**CITY OF BATON ROUGE
PARISH OF EAST BATON ROUGE
DEPARTMENT OF PUBLIC WORKS
SEWER ENGINEERING DIVISION**

ADDENDUM NO. 4

SUBJECT: FLORIDA BOULEVARD PUMP STATION IMPROVEMENTS
CITY-PARISH PROJECT NO. 11-PS-MS-0003

101-C-07	
EAST BATON ROUGE	BATON ROUGE
PARISH	CITY
DESIGNED KTB	DATE AUG 2016
CHECKED CAB	SHEET
DATE	BY
NO.	REVISION DESCRIPTION
FLORIDA BOULEVARD PUMP STATION IMPROVEMENTS	
GRAVITY SANITARY SEWER LINE G8	
PLAN & PROFILE

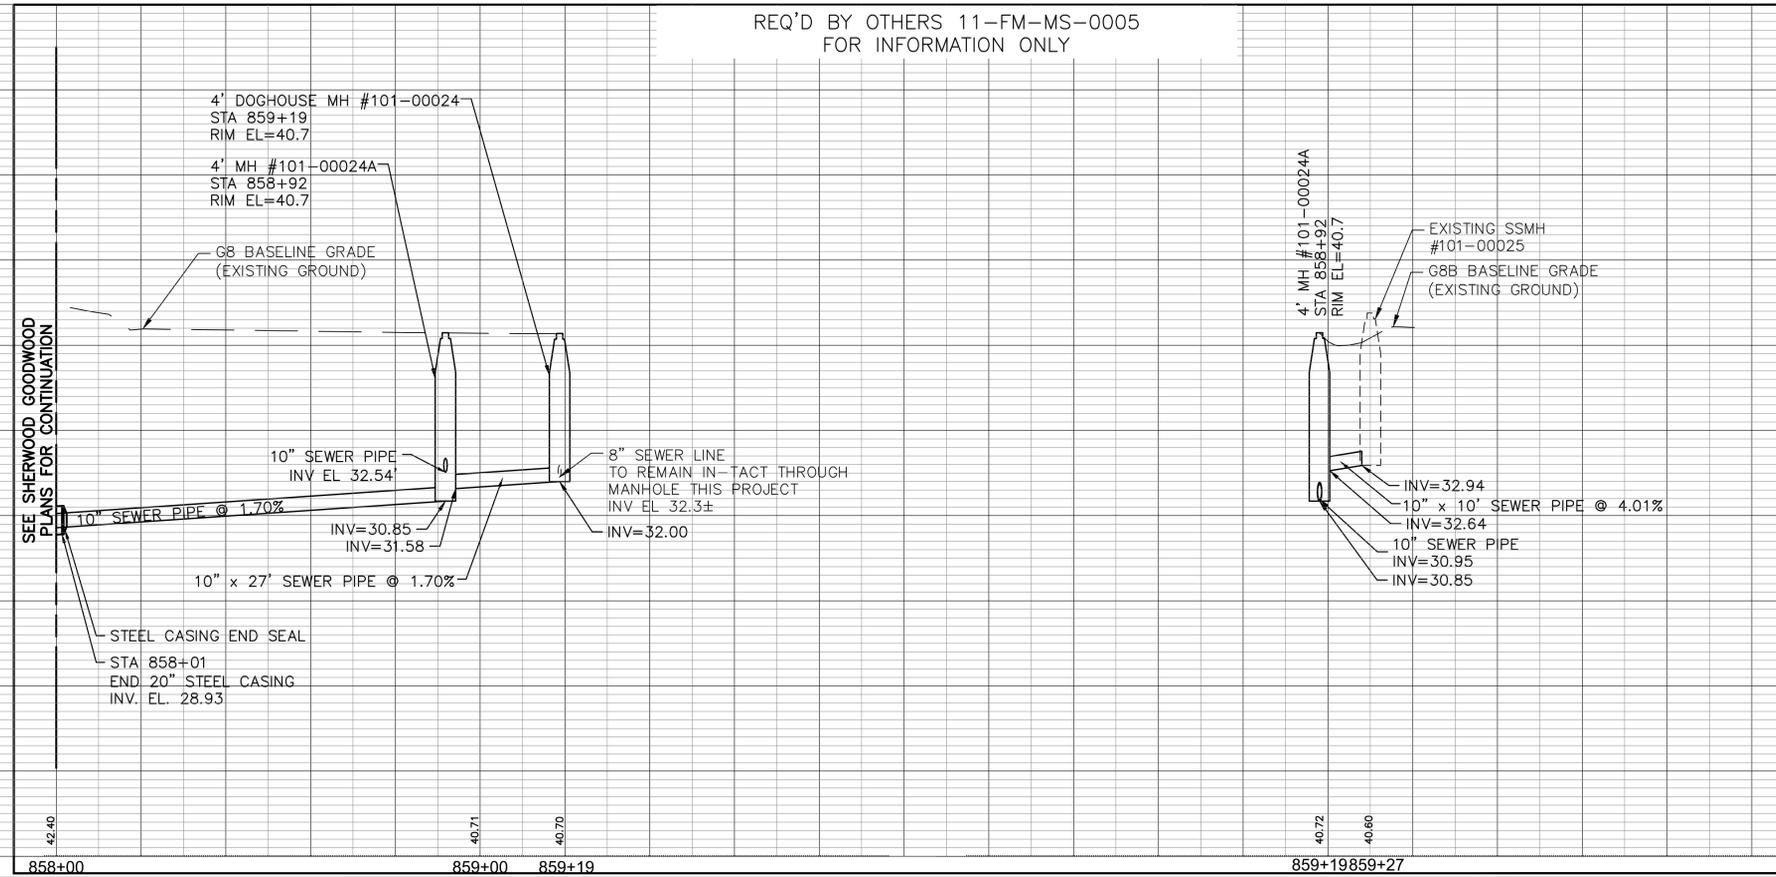
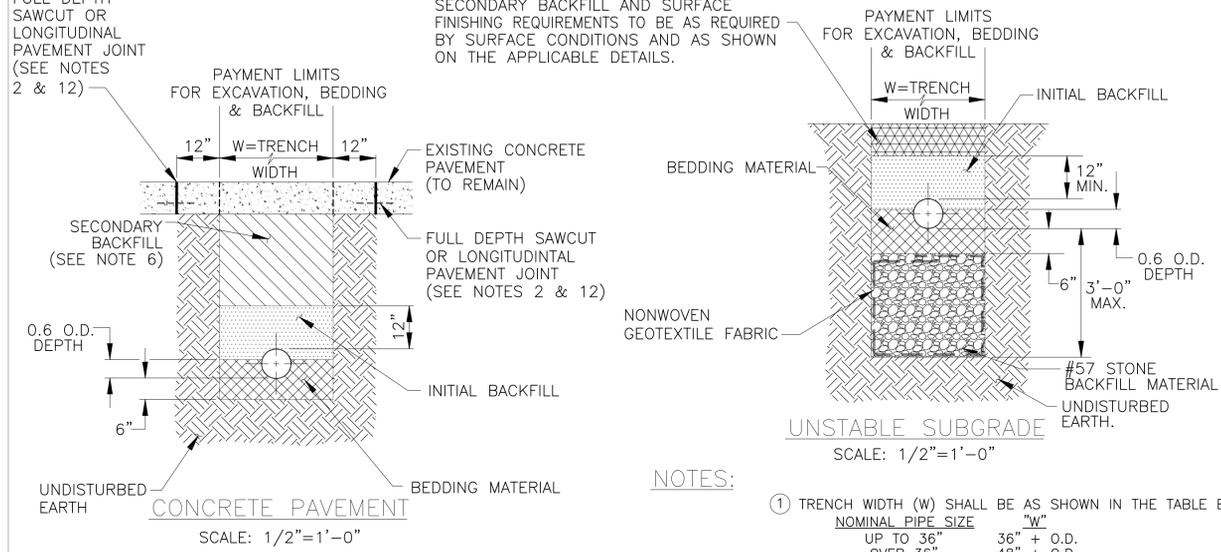
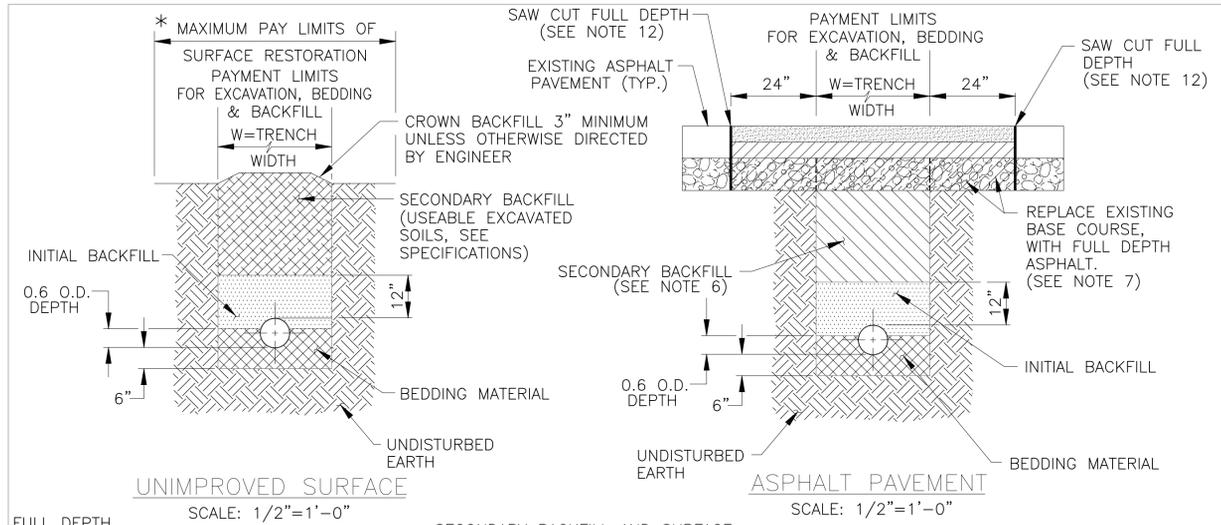
2. **Per this addendum, Standard Plan No. 804-01 (1 of 2) has been replaced with Standard Plan No. 804-01 (1 of 3). Standard Plan No. 804-01 (3 of 3) is not required for this project.**
3. SP 9-5.2, there are many items discussed, but where is this work shown or drawn on the bid documents? All of these items referenced should be shown on the bid documents.

Additional drawings addressing these items are included in this addendum. Removal of plugs and breaking out sewer lines from existing manholes shall be considered incidental to other items on the Bid Form. No separate payment shall be made for this work.

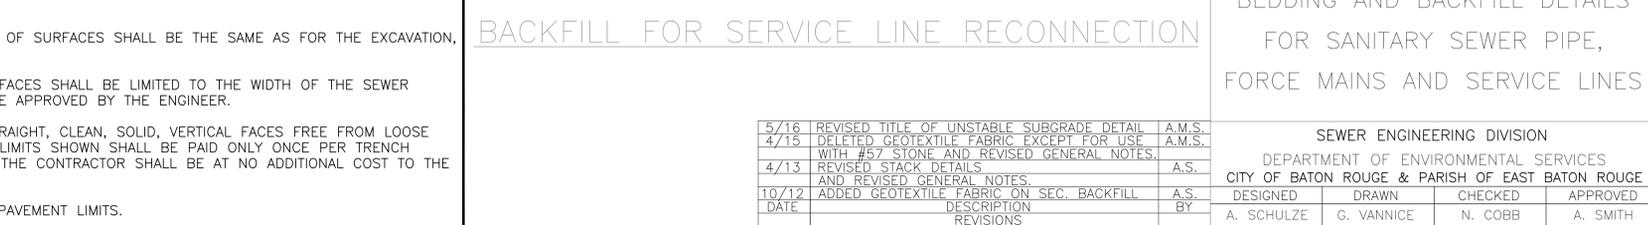
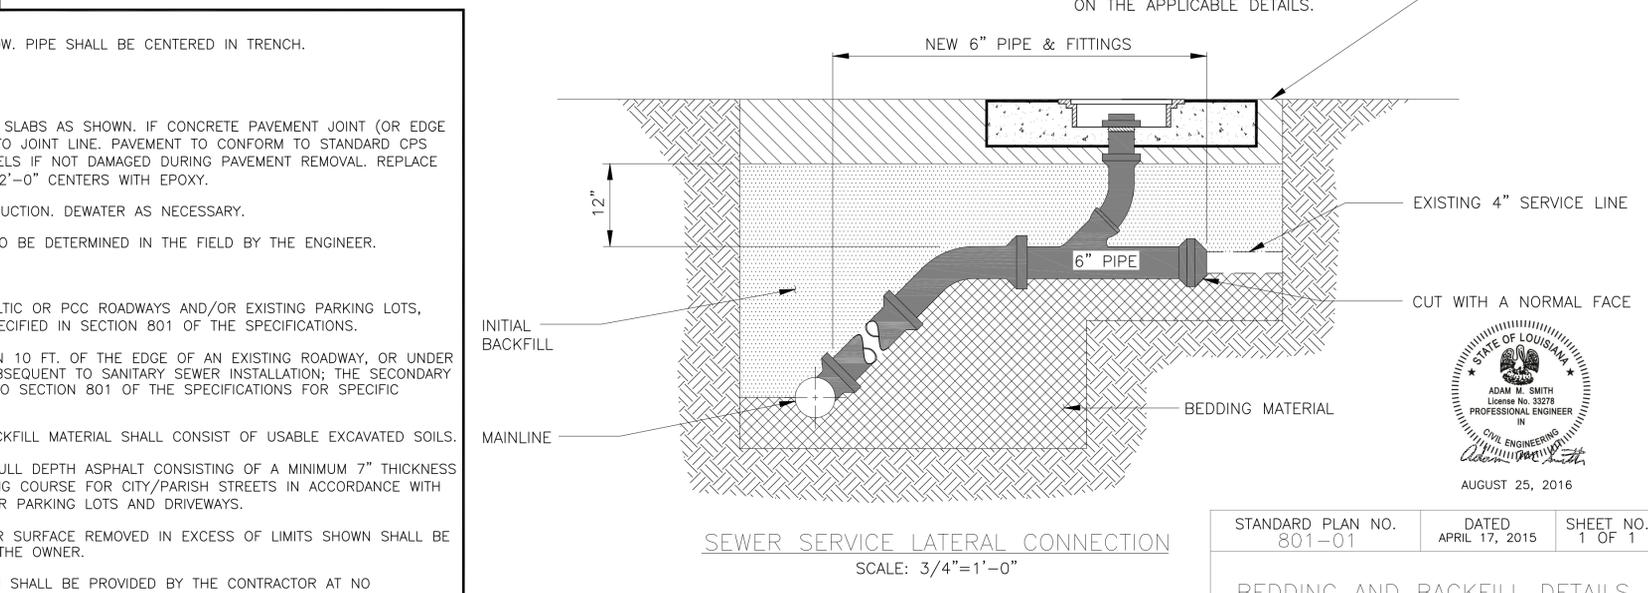
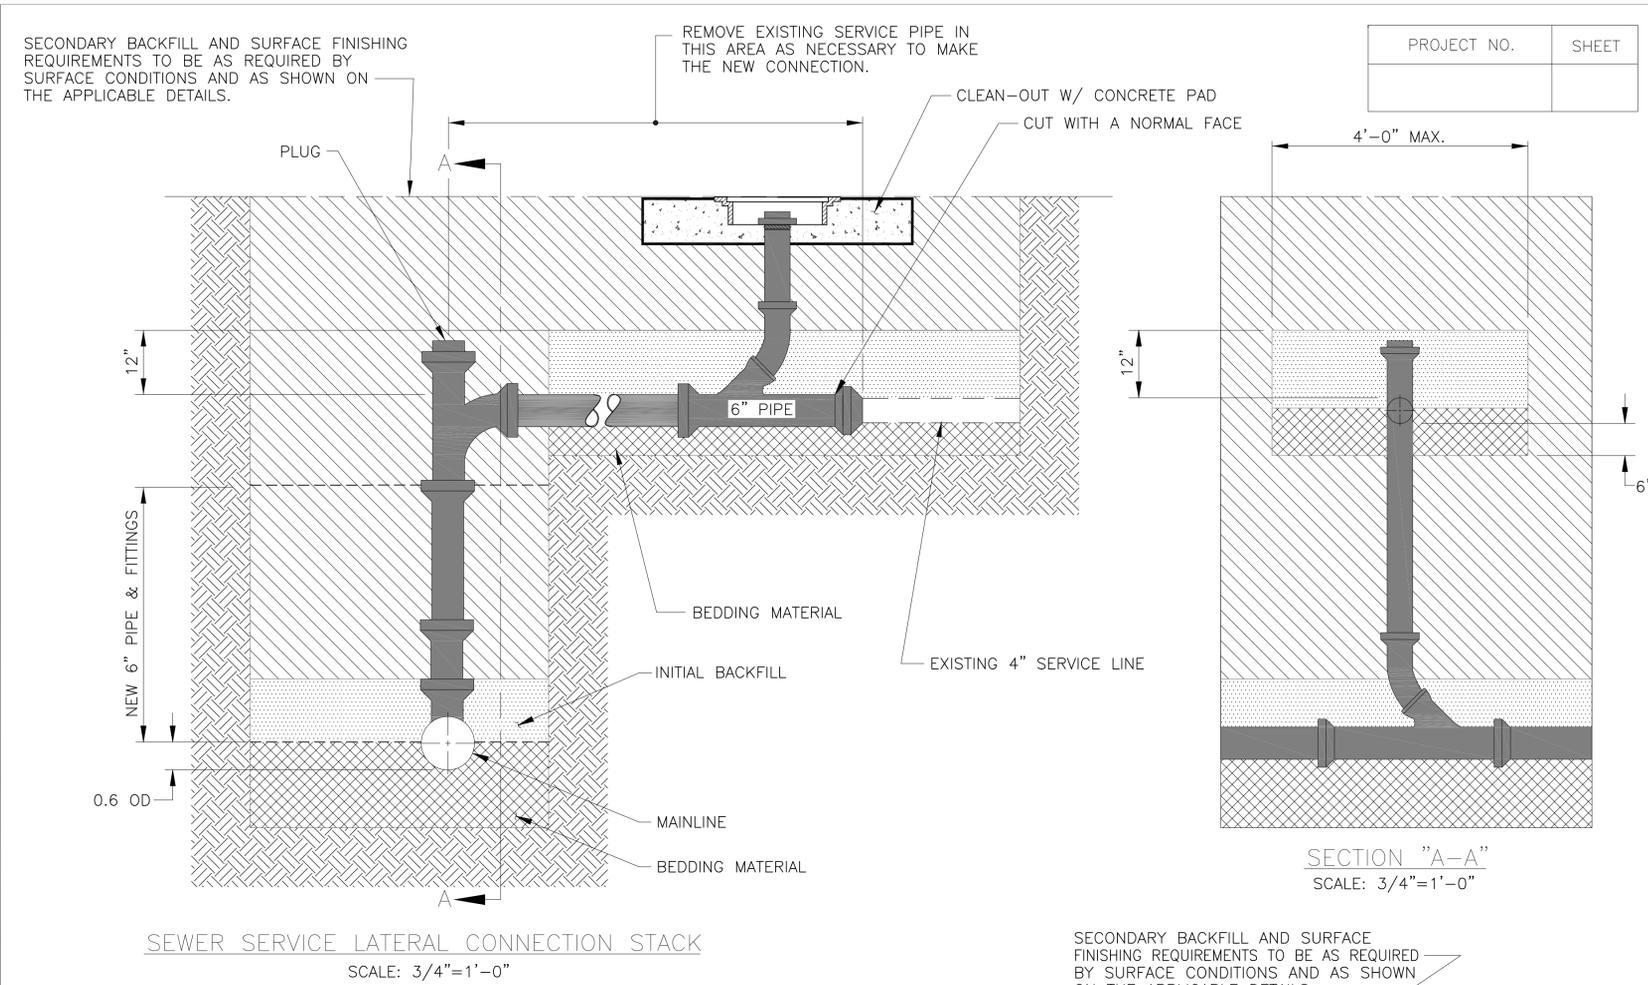
7. Delete Sheet 21-M-01 and Replace with the attached Revised EBR Parish Standard Plan No. 805-03 (1 of 2).
8. Delete EBR Parish Standard Plan No. 801-01 and Replace with attached Revised EBR Parish Standard Plan No. 801-01.

5/16	REVISED TITLE OF UNSTABLE SUBGRADE DETAIL	A.M.S.
4/15	DELETED GEOTEXTILE FABRIC EXCEPT FOR USE WITH #57 STONE AND REVISED GENERAL NOTES.	A.M.S.
4/13	REVISED STACK DETAILS AND REVISED GENERAL NOTES.	A.S.
10/12	ADDED GEOTEXTILE FABRIC ON SEC. BACKFILL	A.S.
DATE	DESCRIPTION	BY
	REVISIONS

STANDARD PLAN NO. 802-01	DATED AUGUST 1, 2011	SHEET NO. 1 OF 2
-----------------------------	-------------------------	---------------------

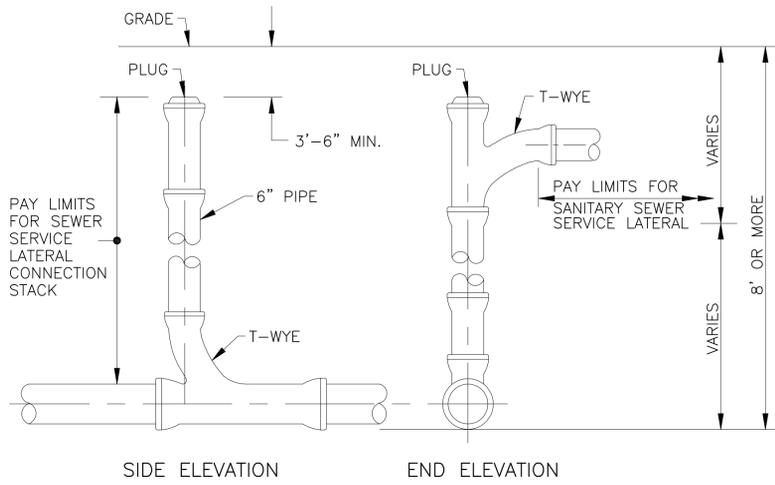
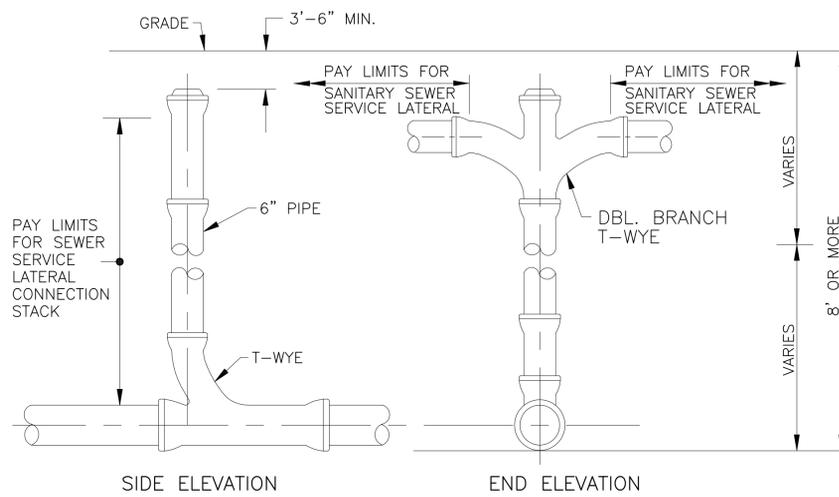
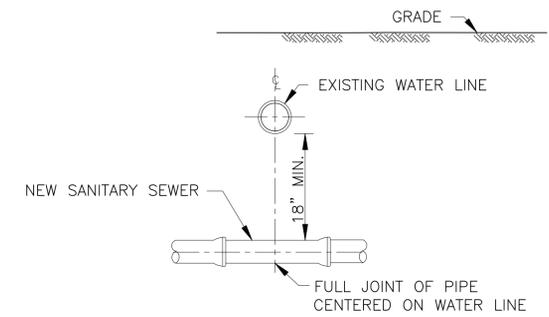
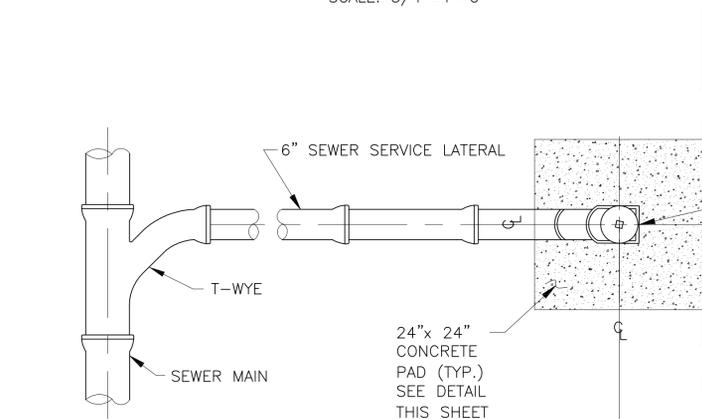
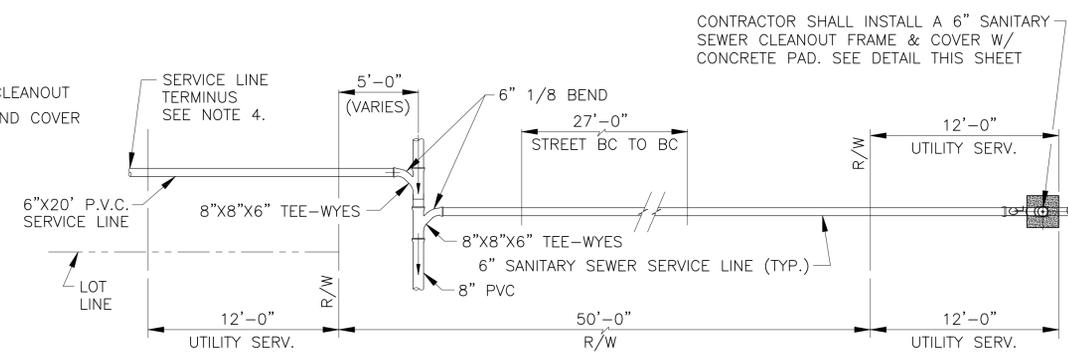
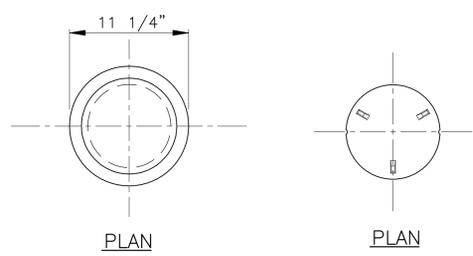
9. Delete EBR Parish Standard Plan No. 802-01 (1 of 2) and (2 of 2) and Replace with attached Revised EBR Parish Standard Plan No. 802-01 (1 of 2) and (2 of 2).

5/16	REVISED LATERAL STACK DIMENSION & ADDED PAY LIMITS	A.M.S.
DATE	DESCRIPTION	BY
	REVISIONS

STANDARD PLAN NO.	DATED	SHEET NO.
803-01	AUGUST 1, 2011	1 OF 3

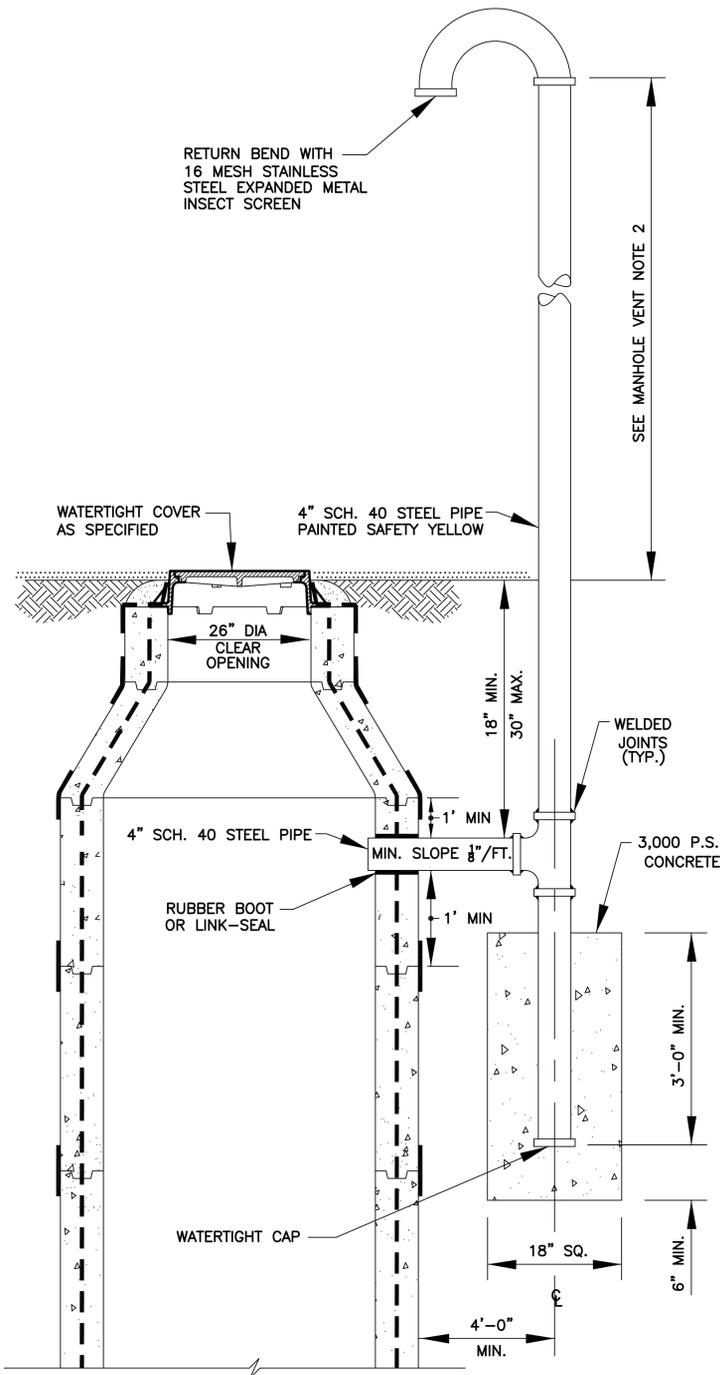
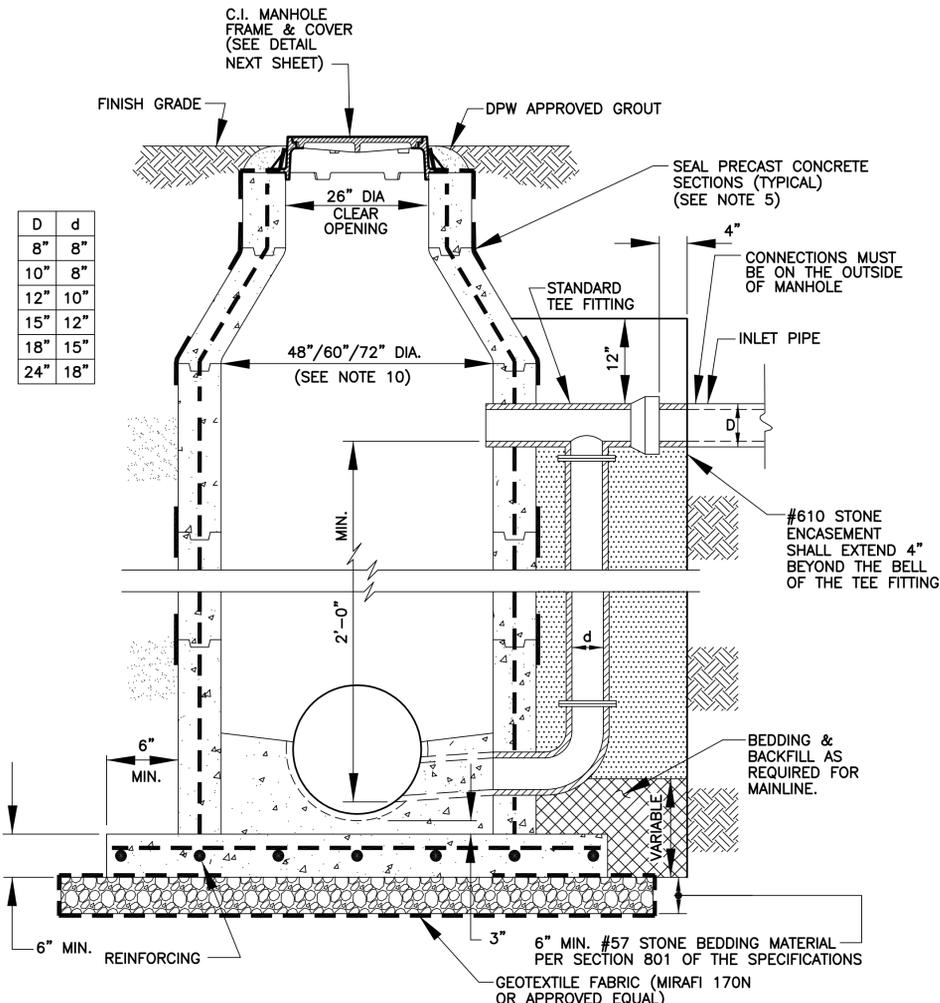
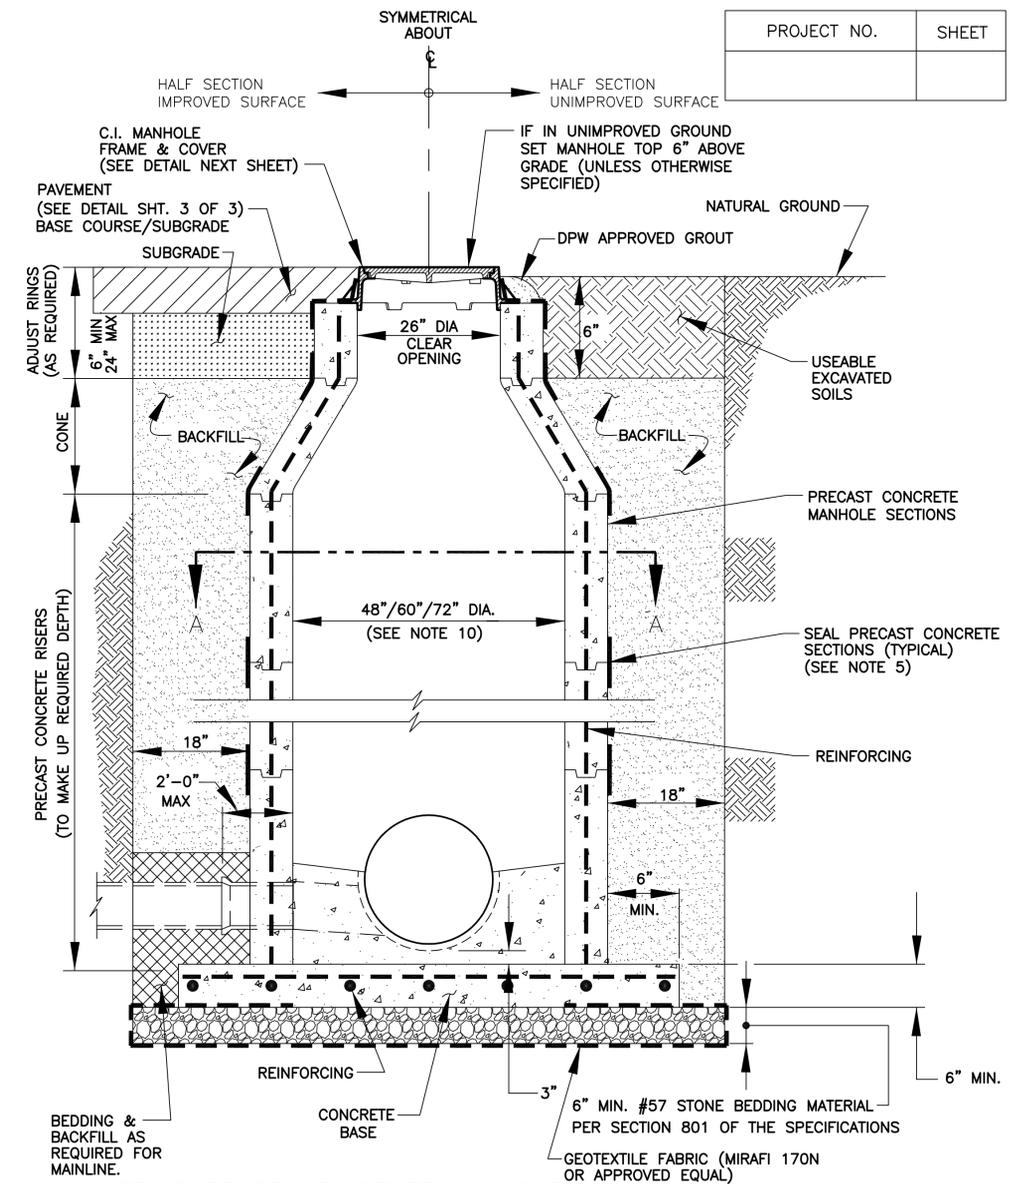
10. Delete EBR Parish Standard Plan No. 803-01 (1 of 3) and Replace with attached Revised EBR Parish Standard Plan No. 803-01 (1 of 3).
11. Delete EBR Parish Standard Plan No. 804-01 (1 of 2) and Replace with attached Revised EBR Parish Standard Plan No. 804-01 (1 of 3).

DATE	DESCRIPTION	BY
5/16	REVISED NOTE 5	A.S.
4-13	REVISED GENERAL NOTES, ADDED DIMENSIONS	A.S.
